A. ADMINISTRATIVE REPORT & DECISION

Project Name: Starbucks at Airport Plaza

File Number: LUA16-000506, ECF, SA-A, MOD

Project Summary: The applicant is requesting Administrative Site Plan Review, Environmental (SEPA) Review, and a street modification, for the construction of a new Starbucks with associated parking, and landscaping. The 0.43 acre site is located within the Commercial Mixed Use (CMU) land use designation and the Commercial Arterial (CA) zoning classification. The proposed building pad is located on the southwest corner of the site, at the northeast corner of Rainier Ave S and S Tobin St. The proposed building would have a gross square footage of approximately 2,000 square feet. Access to the site would be provided via existing curb cuts along Airport Way S, Rainier Ave S, and S Tobin St. The proposal includes 15 parking spaces within surface parking area to the east of the proposed structure.

SOUTH ELEVATION

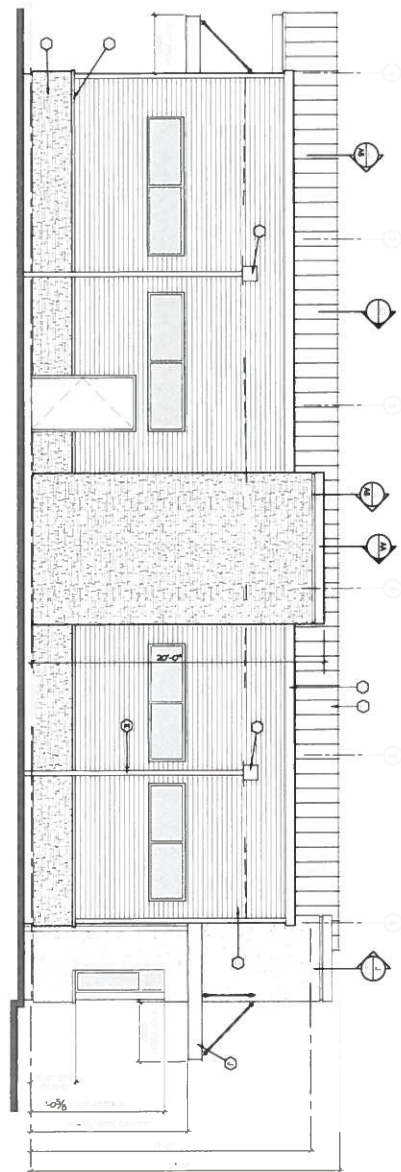
6. The south building elevation (facing S Tobin Street) shall be amended to include weather protection that is a minimum of 4 ½ feet wide along 75 percent of the building façade. The weather protection shall have a height between 8 and 15 feet. The revised building elevation shall be submitted at the time of Building Permit review for review and approval by the Current Planning Project Manager.

7. Building lighting fixtures shall be provided along the south façade (facing S Tobin Street). Details of the proposed lighting fixtures shall be submitted to the Current Planning Project Manager for review and approval at the time of Building Permit review.
8. The curb ramps at the northeast corner of S Tobin Street and Rainier Ave. S intersection shall be brought up to current ADA standards.
